Development Application DA2020/0061 - 59 Cutler Road CLONTARF NSW 2093

61 Cutler Road response to 59 Cutler Road DA Development Application DA2020/0061

Table 3. Retaining wall height

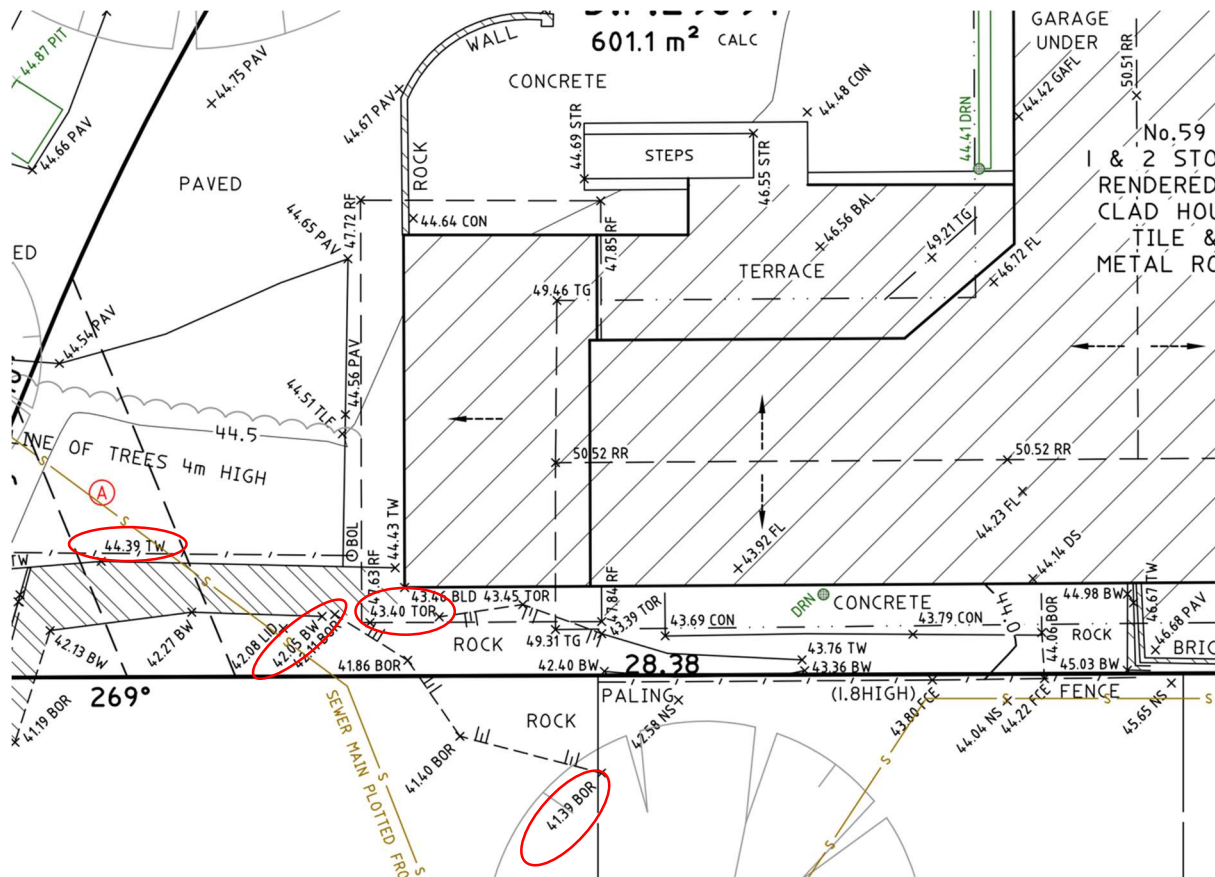
- All southern walls are located into the minimum side set back.

The property is built on top of the retaining wall within the property, adding to the overall height of the development when viewed from 61 Cutler Road and adding to the overlooking issue.

This is exacerbated with 19 extensive glazing, causing unacceptable privacy impact to 61 Cutler Road, looking directly into living room, kitchen, 3 bedrooms and dress room and all open space area including laundry hanging area.

Figure 1: Retaining wall in 59 Cutler Road.

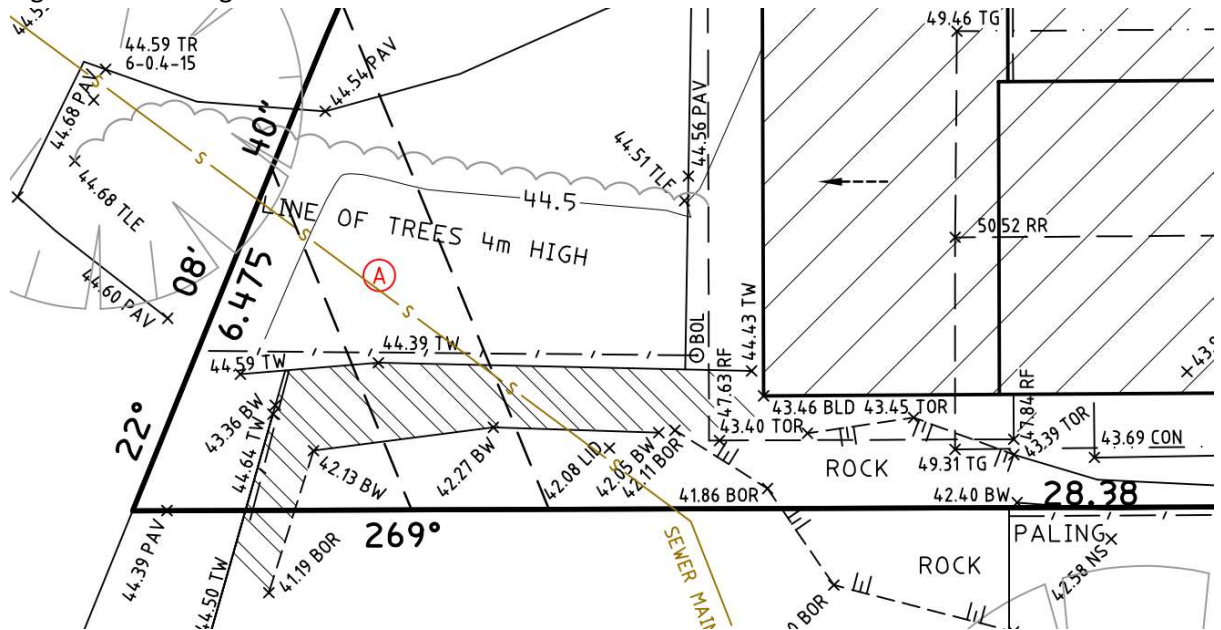
The civil works plans ignore the existing circa 2m+ high stone retaining wall approximately 1m north of the southern boundary. Therefore the proposed stormwater pits are floating

Existing retaining wall should be assessed for condition and ability to support the new larger structure and remediated during construction if required.

Figure 2: Stormwater and Rainwater assets 'floating' over retaining wall

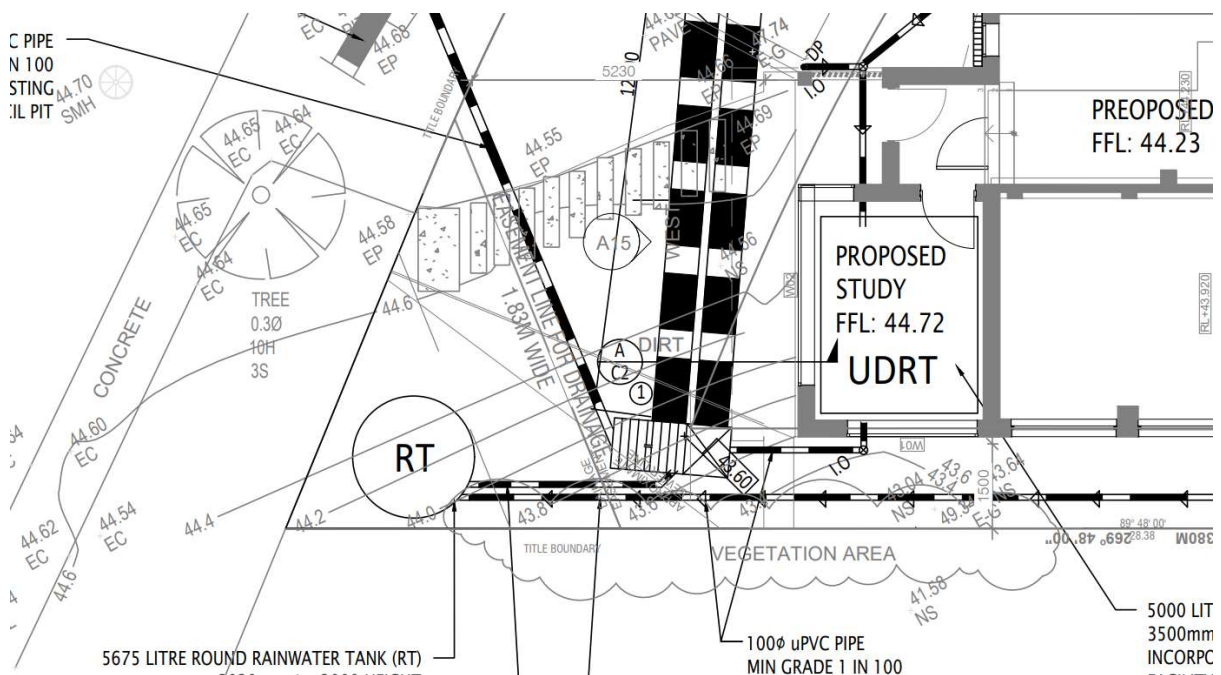
over the wall and need to relocate further north. There is an existing sewer pit at the base of the retaining wall which cannot have stormwater assets constructed above.

Sewer manhole is believed to be in 59 Cutler Road not 61 Cutler Road as shown on 18624 Detail drawing by CMS surveyors.

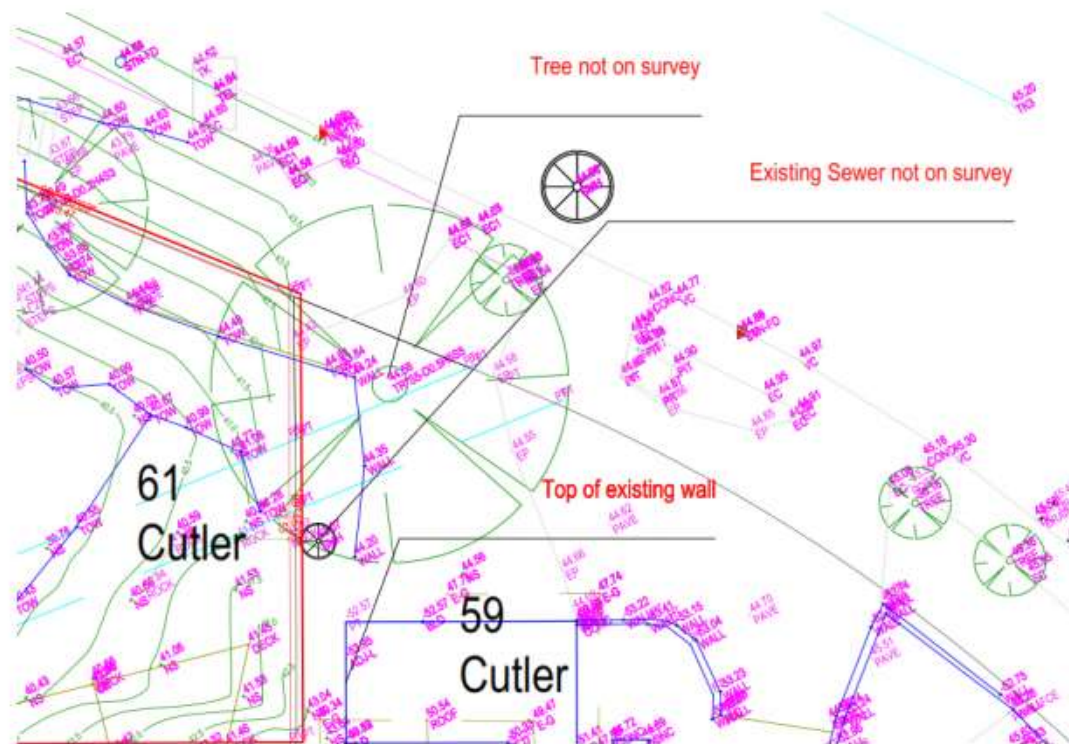
The current Civil plans propose to remove an existing tree which acts as a visual screening between our properties and replaces it with a 2m tall rainwater tank. The rainwater tank is also placed over the retaining wall which will not be possible. This will be very unsightly from the street front and our property and we request any rainwater tank be hidden below decking or similar.

The location on top of the existing stone wall retaining structure is unlikely to be adequate for this additional loading of c. 5.5t. The tree is not noted to be removed on the plans and does not appear in their survey. See below extract of survey that shows the existing tree, retaining wall and sewer pit in the subject property close to the southern boundary.

Retaining wall on the southern boundary in excess of 2m not noted in DA.

Condition of existing retaining wall

Lack of access for maintenance due to lack of side setback
